Recall Bulletin

SUBJECT: Power Lift Gate Prop Rod Recovery

MODELS: 2008-2012 Buick Enclave
2009-2012 Chevrolet Traverse
2007-2012 GMC Acadia
2007-2010 Saturn Outlook
Built Prior to March 10, 2012 Equipped with Power Lift Gate (TB5 or E61)

This bulletin is being revised to include additional vehicle population and extend the customer reimbursement date for this new population. The involved vehicle build date has been expanded through March 9, 2012. Please discard all copies of bulletin 15240B.

2878222

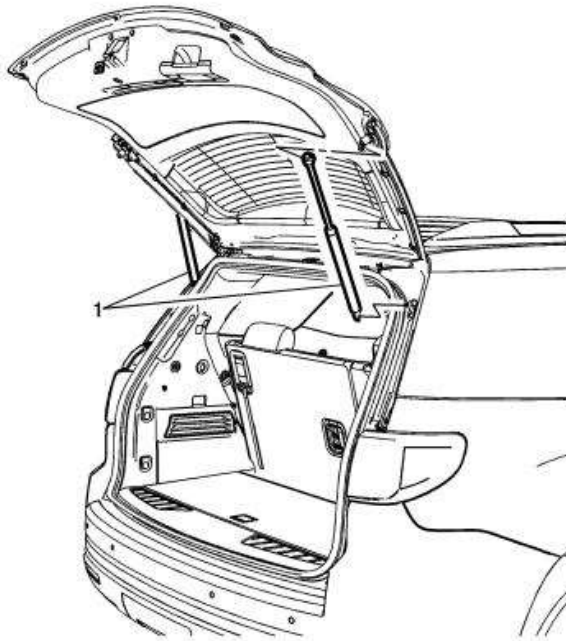
Note: GM engineering has determined that improved durability of the lift gate strut can be realized by installing the strut assembly with the rod end facing downward (attached to the lift gate) when the lift gate is in the closed position. In this orientation, dust and dirt does not collect on the strut housing to rod seal, which can cause wear on the seal.

Note: When replacing or repositioning the lift gate struts, install the strut assembly with the strut body end attached to the vehicle body and the rod side attached to the lift gate (1).
